Claremont Business Park 2 Filing No. 1

PCD # SF-20-014

**FINAL DRAINAGE REPORT FOR CLAREMONT
COMMERCIAL FILING NO.3
EL PASO COUNTY COLORADO**

**FINAL DRAINAGE REPORT FOR CLAREMONT
COMMERCIAL FILING NO.3
EL PASO COUNTY COLORADO**

INLET ON A CONTINUOUS GRADE

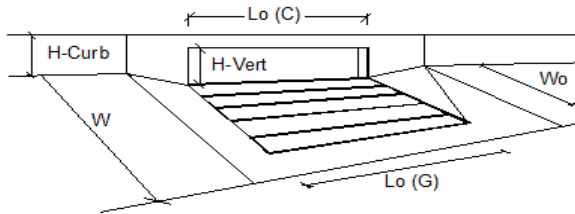
Revise so that it matches the CD's and drainage plan. Inlet 1 is indicated as 15' on the CD's.

Unit length is 5'. # of units is 3.

INLET ON A CONTINUOUS GRADE

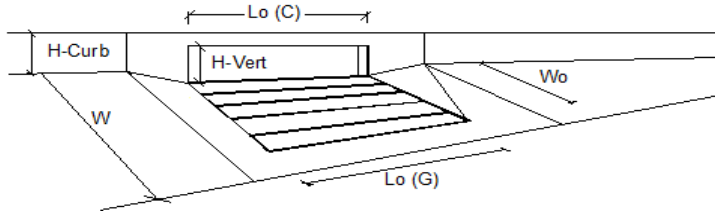
Revise so that it matches the CD's and drainage plan. Inlet 2 is indicated as 10' on the CD's.

Unit length is 5'. # of units is 3. Changed to 15'.

INLET ON A CONTINUOUS GRADE

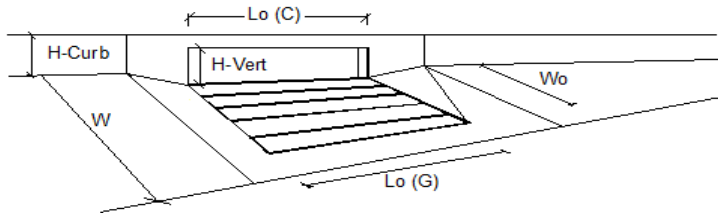
Revise so that it matches the CD's and drainage plan. Inlet 3 is indicated as 15' on the CD's.

Unit length is 5'. # of units is 3.

INLET ON A CONTINUOUS GRADE

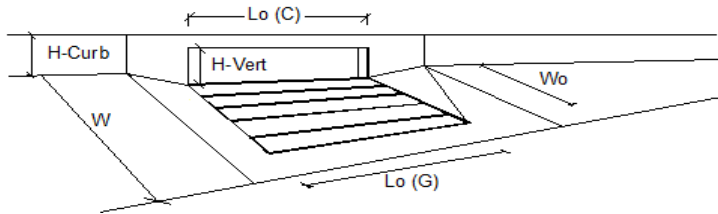
Revise so that it matches the CD's and drainage plan. Inlet 4 is indicated as 10' on the CD's.

Unit length is 5'. # of units is 3. Changed to 15'.
